City of Pompano Beach – DRC-Pre Application Comments

Project Name: Archi-One

Process Number: PZ22-12000039

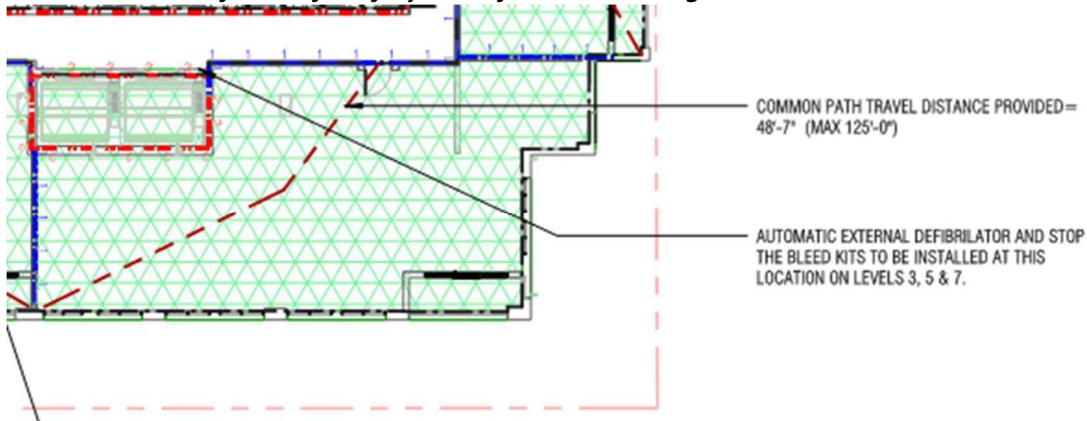
() F-121.2.7.1 Multi story occupancies listed above shall place an AED and SBK on every other floor beginning on the first floor. The AED and SBK shall be placed near the elevator(s) beginning in the first-floor lobby (first floor, third floor, fifth floor etc.)

Requested AED and SBK elements will be located adjacent to elevator landings at first, third, fifth and seventh levels. Refer to Life Safety Plans for note locating these elements.

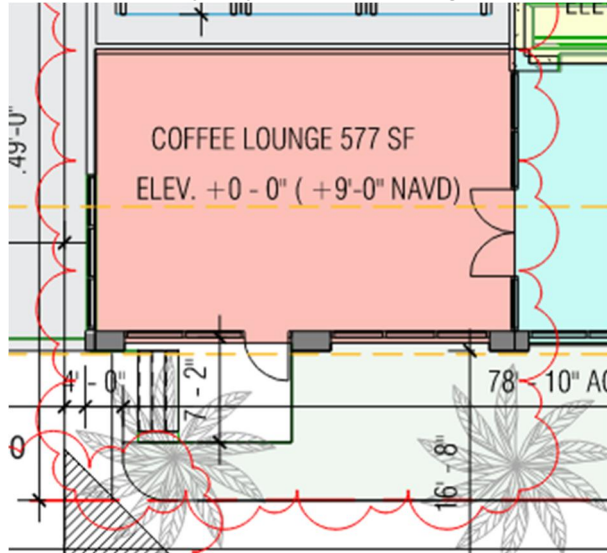
6. The previous comment pertaining to the "Coffee Lounge" doors needs further clarification. The response stated that the Coffee Lounge is proposed to be accessed from the building lobby... Please show the doorway/access between the Coffee House and the lobby.

A set of double doors have been added connecting the resident Coffee Lounge to the building lobby. An additional door has been added at the storefront providing direct egress from the space to the outside. A set of steps connect this egress door to the sidewalk.

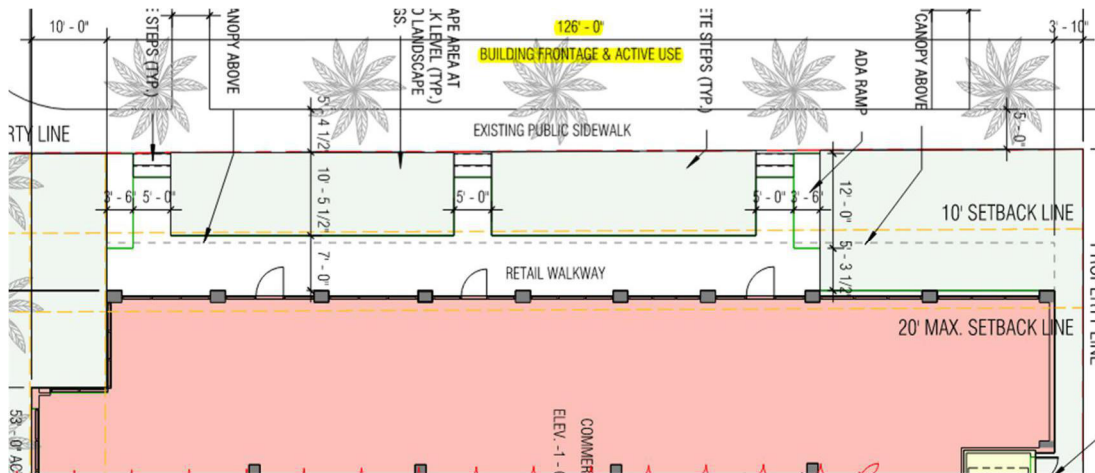
8. The minimum required Building Frontage for North Federal Hwy is 90% of the length of the property along that right-of-way, or 126 feet minimum. The proposed outdoor courtyard area is not considered building frontage and cannot be counted toward the requirement.

Building frontage along N Federal Highway has been widened in order for the building to comply with the 126'-0" minimum requirement. This façade had to be pushed back further into the setback in order to maintain compliance with the minimum permeable area requirement. Regardless of this change, the frontage remains within the maximum setback requirement.

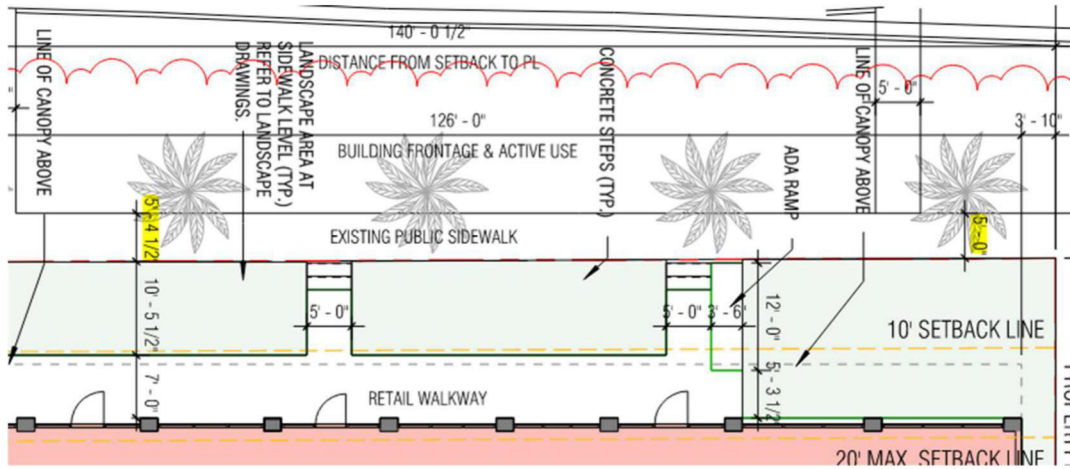
10. Coordinate with the City's Urban Forestry Division regarding placement, location and size of the site visibility triangles. Specifically, clarify where the 25-foot site triangle requirement that is shown on the plan is from. The site triangle that the Zoning Code requires at street and/or driveway intersections is the 10-foot triangle in Section 155.5101.G.9: At roadway intersections other than those involving a State road or a designated alley, and where a driveway intersects with a local street, collector street, minor arterial street, or principal arterial street, a sight triangle shall be established at each corner of the intersection. Each sight triangle shall be measured from the intersection of the extended curb or edge-of-pavement lines for the intersecting roadways (or intersection roadway and driveway), to a point located ten feet along the curb or edge-of-pavement line for one roadway/driveway, to a point along the curb or edge-of-pavement line for the other roadway/driveway located ten feet from the original point

25' Visibility Triangle has been removed from the project. 10' Visibility triangles have been added to all corners of driveways and intersections for the project.

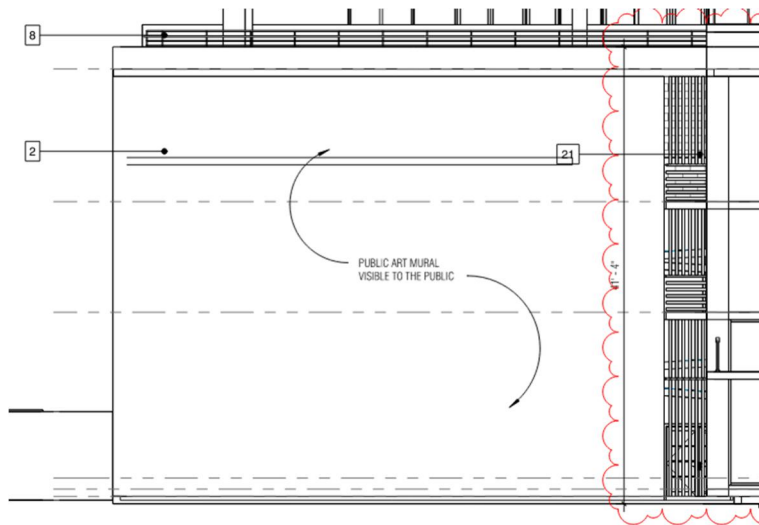
14. For Density Bonus option #1, identify whether a piece of artwork or a fee will be provided to satisfy the requirement of the Bonus.

A piece of artwork valued at 1% of the project's construction costs or a maximum of \$250,000 will be added to the project displayed on exterior walls facing N Federal highway. A note showing location of artwork has been added to West elevation. Lot Occupation table includes this statement as well.

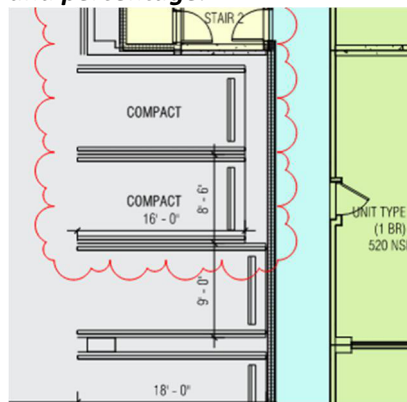
15. Identify the line that appears on the site plan along the south side, between the building and the south right-of-way line that extends from approximately 18 feet east of the west right-of-way line to the edge of pavement at NE 22 Ave.

Line has been deleted from plans.

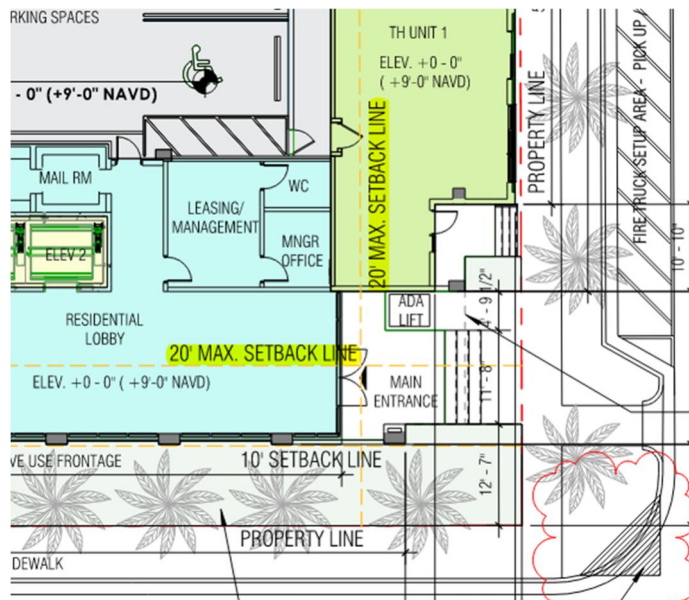
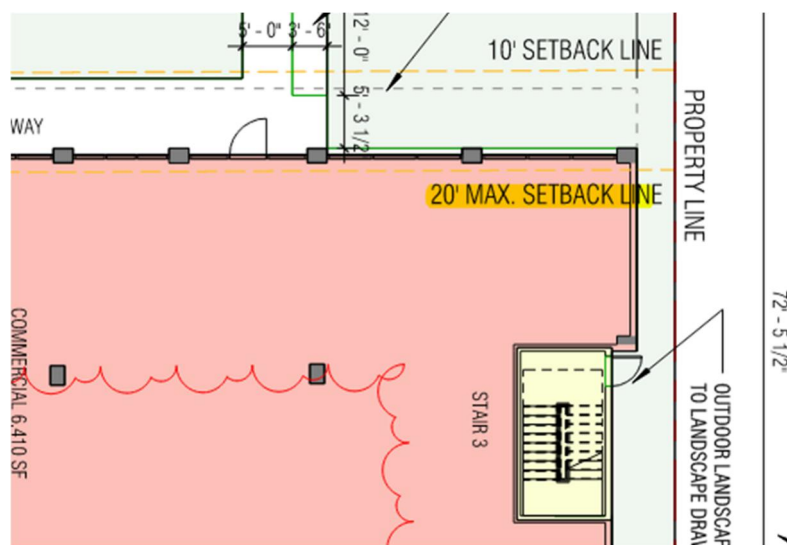
16. Various parking spaces measure less than the standard parking space of 9 feet wide and 18 feet long. Provide the number and percentage of compact parking spaces. Section 155.5102.1.2 allows up to 20% of spaces in a parking garage to be 8.5 feet by 16 feet.

17. The site plan shows a 10-foot setback line on the three street fronts. The maximum front and street side setbacks in the Core Sub-Area is 20 feet. Revise the site plan to provide the correct setback.

Compact parking spaces have been identified on the plans with a "COMPACT" label, all other (non-ADA) parking spaces comply with the minimum 9'x 18' requirement. Compact parking space total 11 spaces representing 8.94% of the total parking spaces provided in the parking structure. Parking and Loading Table on the Project Data chart has been revised to show the compact parking space numbers and percentage.

Maximum 20' setback line has been added to the three sides of the property facing a street on the siteplan. Building Setback table on Project data chart has been updated to show the maximum setback as well.

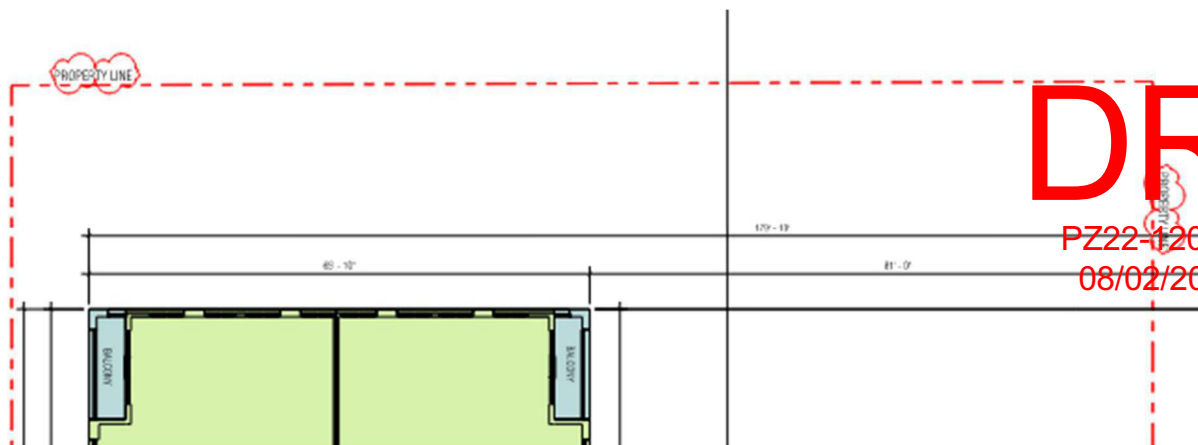
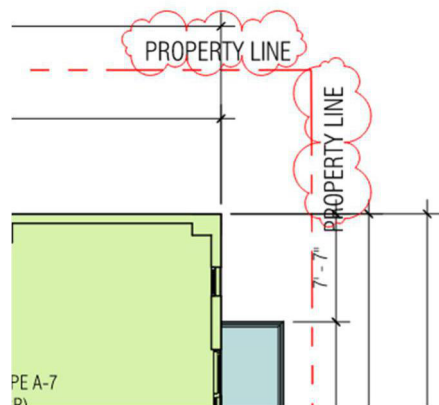
18. Show the property lines on all floor level plans, with proposed building setbacks to property lines for each level.

Property lines and notes labeling all property lines have been added to plans at all levels.

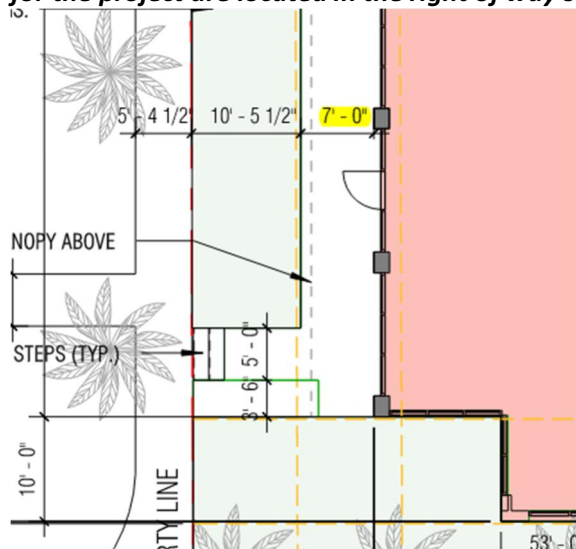
20. In the TO/EOD, sidewalks in the right-of-way are permitted to be 5 feet wide. Walkways/sidewalks on private property must be a minimum 7 feet wide in commercial and mixed-use Zoning districts, pursuant to Section 155.5101.1.3.a.i. Revise the plans to provide the minimum required width for all sidewalks and walkways.

Walkway at N. Federal Hwy has been increased in width to 7'-0" at it's narrowest. All other sidewalk for the project are located in the right of way so they are a minimum of 5'-0".

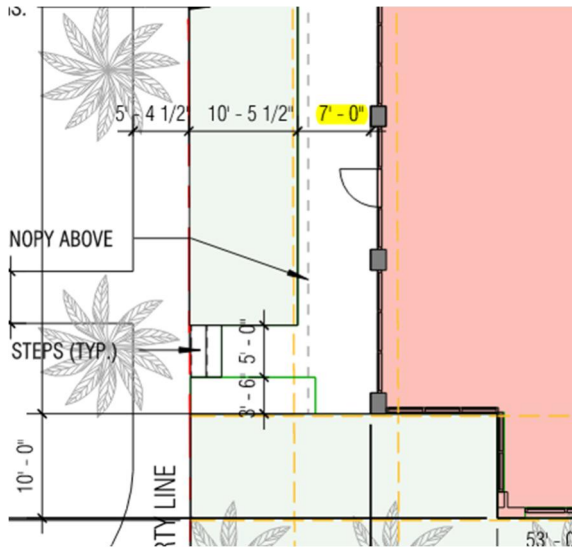
21. On the Site Plan, sheet A-01, the "Retail Walkway" at the west side of the building has a dimension of 5 feet 8 inches from the edge of the walkway at the planters to the face of the building. It appears that the building columns protrude into the walkway. Revise the dimension for the walkway width from the outer edge of the walkway at planters to the face of the columns, which appears to be the narrowest width of the walkway.

Dimension has been revised to show the condition at the narrowest width for the walkway. Width is now 7'-0".

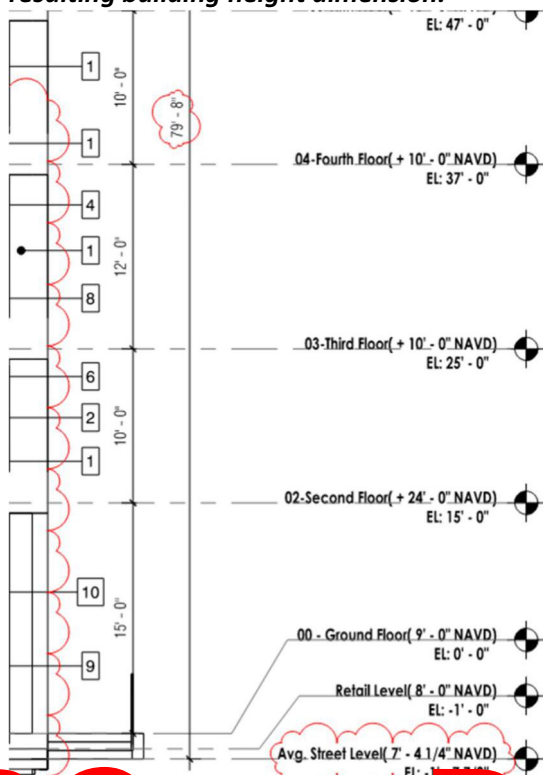
22. Verify that the dashed line that denotes average street level is consistent with the average elevation of the finished grade at the front of the proposed structure. If not, revise elevations to show the average elevation of the finish grade at the front of the structure. Section 155.9401.G identifies the measurement of building height as the measurement of the vertical distance from the average elevation of the existing finished grade at the front of the structure to the top of the roof for a flat roof.

Average street level has been recalculated to average out the elevation at the front of the structure as per the elevation points shown on the civil plans. Average street level went from 7'-0" NAVD to 7'-4 1/4" NAVD. Elevations have been updated accordingly showing the updated street level as well as the resulting building height dimension.
